UNITED STATES
NUCLEAR REGULATORY COMMISSION
WASHINGTON, D. C. 20555

NINE MILE POINT NUCLEAR STATION, UNIT NO. 1

Amendment No. 23
License No. DPR-63

SAFETY EVALUATION BY THE OFFICE OF NUCLEAR REACTOR REGULATION
SUPPORTING AMENDMENT NO. 23 TO FACILITY OPERATING LICENSE NO. DPR-63

Figure 2.1.1. Flow Biased Scram and APRM Rod Block

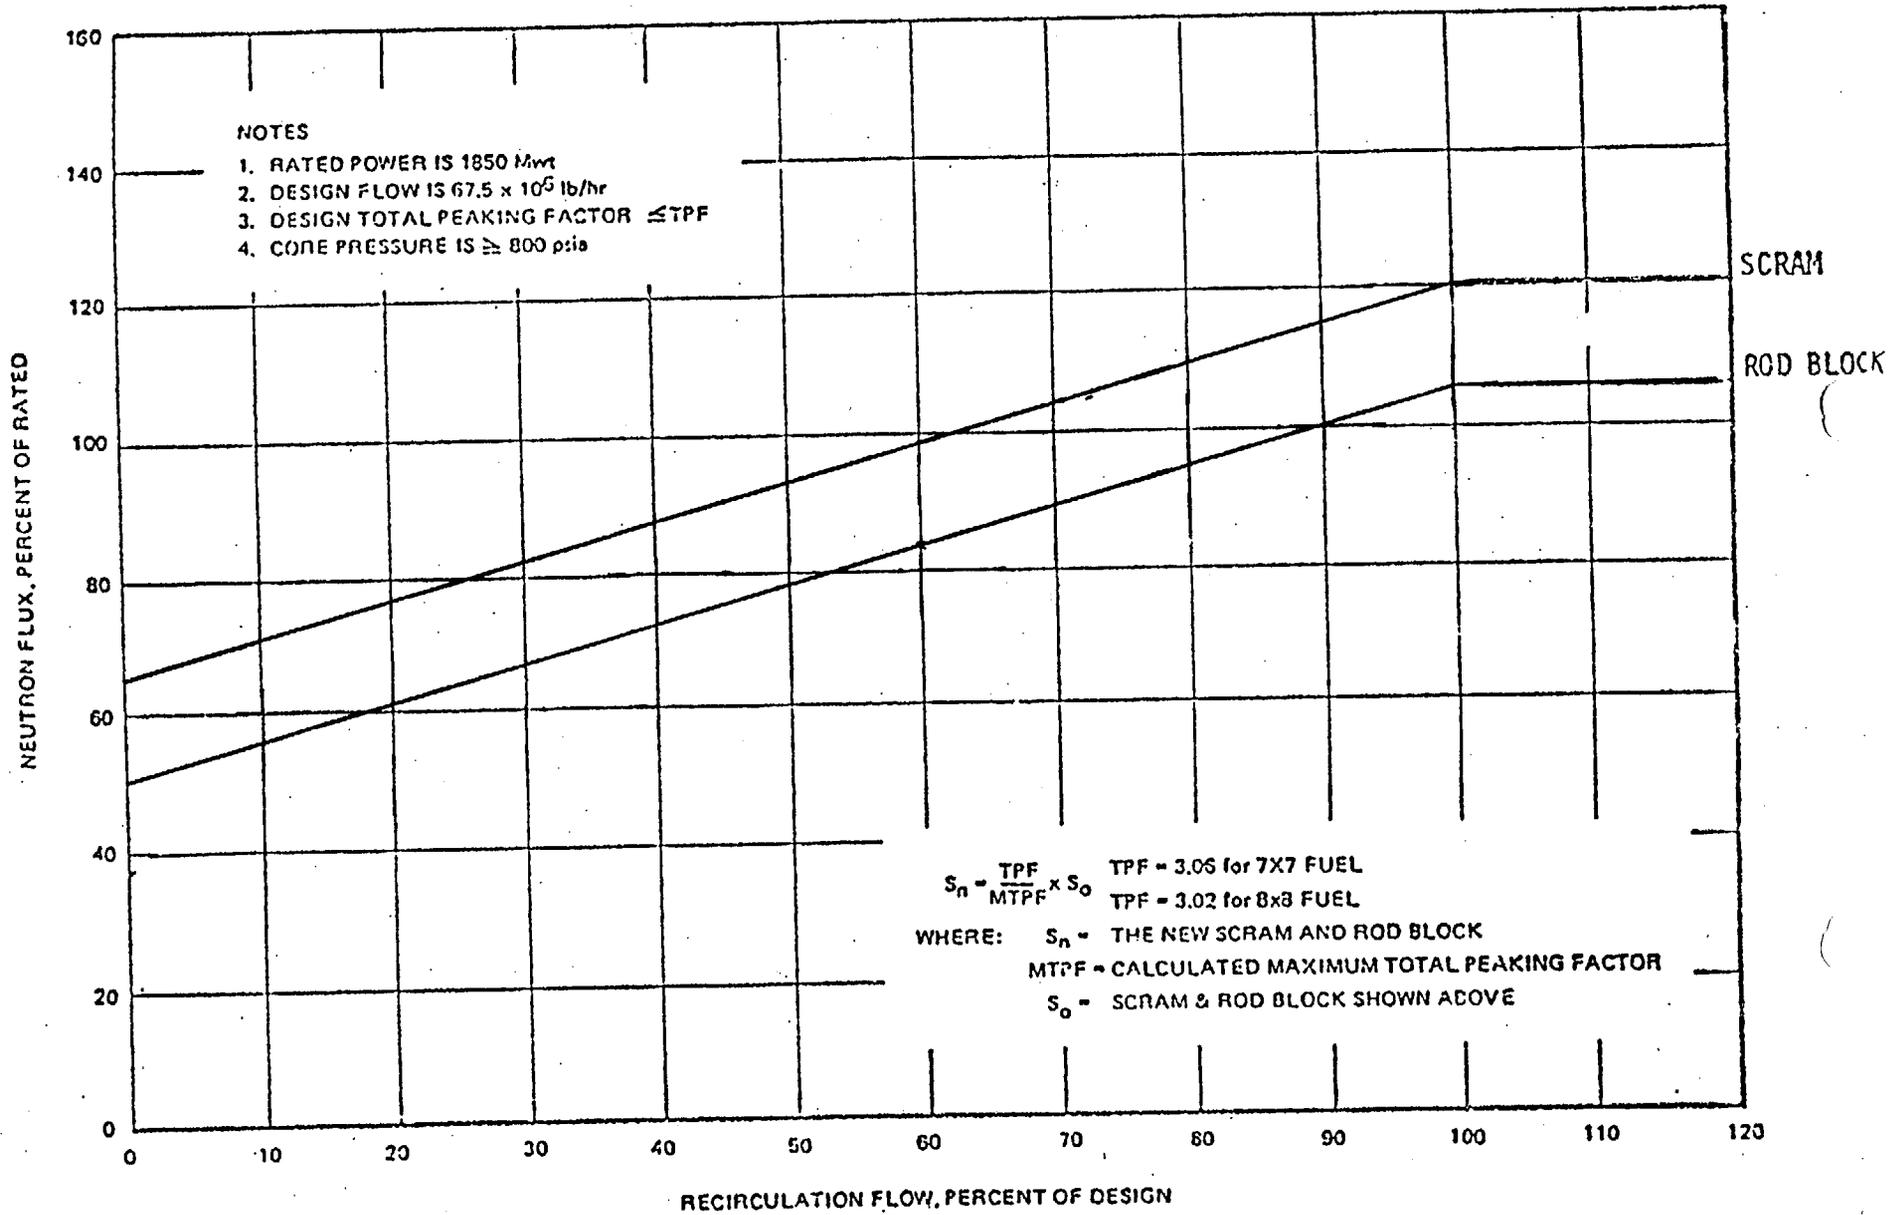
The amendment modifies the Technical Specifications by (1) modifying the Flow Biased Scram and APRM Rod Block curve; (2) replacing assembly averaged power-void relationships with a limiting power/flow curve; and (3) increasing the operating Minimum Critical Power Ratio (MCPR) for 7x7 fuel. The amendment also deletes the current Specification 6.12, Respiratory Protection Program in accordance with our letter dated July 29, 1977.

2.1 NMPC proposes to change the Flow Biased Scram and APRM Rod Block curve for the NMP-1 to provide operational flexibility. In addition to modifying the Rod Block and Scram curve, NMPC proposes to use a power/flow curve as the locus of limiting allowable thermal power as a function of flow. By using these power and flow conditions as constraints to power operation the power-void relationships are satisfied and the current Assembly Averaged Power-Void Relationships using B factors (Power-Void Limits) can be removed from the Technical Specifications. All reactor safety analyses are based on these power and flow constraints and the power/flow-condition are such that the occurrence of an abnormal operating transient will result in operation still within safety limits. The basis for these proposed changes are provided in Reference 1.

The modifications in the APRM rod block and the flux scram lines provide a power/flow envelope which satisfies the same minimum safety criteria as previously reviewed by the NRC staff and found acceptable in the Safety Evaluation Report associated with license amendment No. 16, dated June 17, 1977. NMPC has provided the results of analyses and sensitivity studies to demonstrate that these criteria were met. The consequences of any abnormal transient or accident has been verified to be within safety limits previously found acceptable in the Safety Evaluation Report dated June 17, 1977, noted above.

The APRM rod block setpoint is selected to allow for failed instruments for the worst allowable power profile. It is demonstrated that even if the operator ignores all alarms during the course of this transient, the rod blocks will stop rod withdrawal when the CPR is 1.06 (the CPR safety limit). At powers and flows lower than the 85%/61% condition within the proposed operating envelope, a RWE results in smaller Δ CPR values. The use of the present K_f factors limit the control rod position such that the resulting MCPR's are conservative and bound the Δ CPR due to a RWE. The consequences of the RWE transient decrease at lower flows and the effective MCPR required by the use of the K_f values become increasingly conservative.

Figure 3.1.7.aa
NINE MILE POINT UNIT 1
LIMITING POWER FLOW LINE

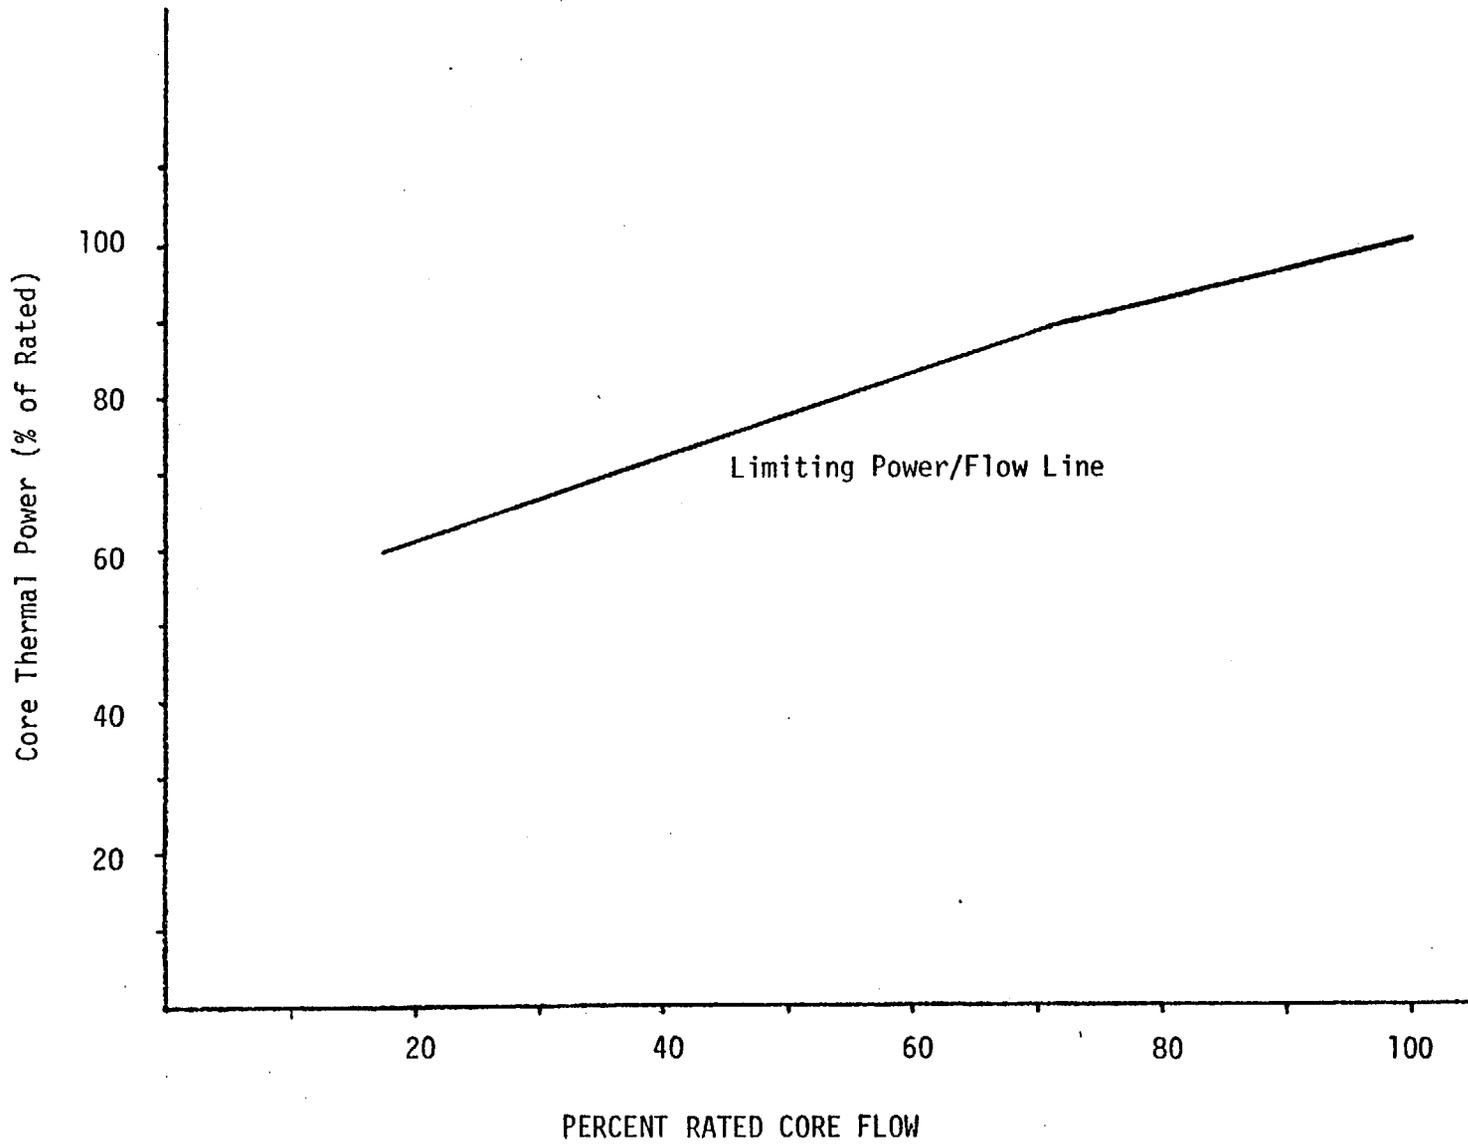
The power/flow relationship shall not exceed the limiting values shown in Figure 3.1.7.aa.

The power/flow curve is the locus of critical power as a function of flow from which the occurrence of abnormal operating transients will yield results within defined plant safety limits. Each transient and postulated accident applicable to operation of the plant was analyzed along the power/flow line. The analysis⁽⁷⁾ justifies the operating envelope bounded by the power/flow curve as long as other operating limits are satisfied. Operation under the power/flow line is designed to enable the direct ascension to full power within the design basis for the plant.

Currently, power void limits (B-Factors) are utilized in the NMP-1 Technical Specifications to assure compliance with the assembly void fraction assumption used in the Loss of Coolant Accident (LOCA) analysis. These power void limits in the Technical Specifications are no longer necessary when the proposed power/flow limit line is added to the Technical Specifications since the combination of MCPR operating limits and the proposed power/flow limit line provide adequate assurance that operating conditions will be more conservative than the initial conditions assumed in the LOCA analysis for NMP-1.

The LOCA analysis performed at the 100% power/100% flow point has been found to be limiting in relation to other points along the proposed power/flow curve. The operation of NMP-1 within the envelope bounded by the proposed power/flow curve assures that the current LOCA analysis basis is conservative with respect to all operating conditions and therefore is acceptable.
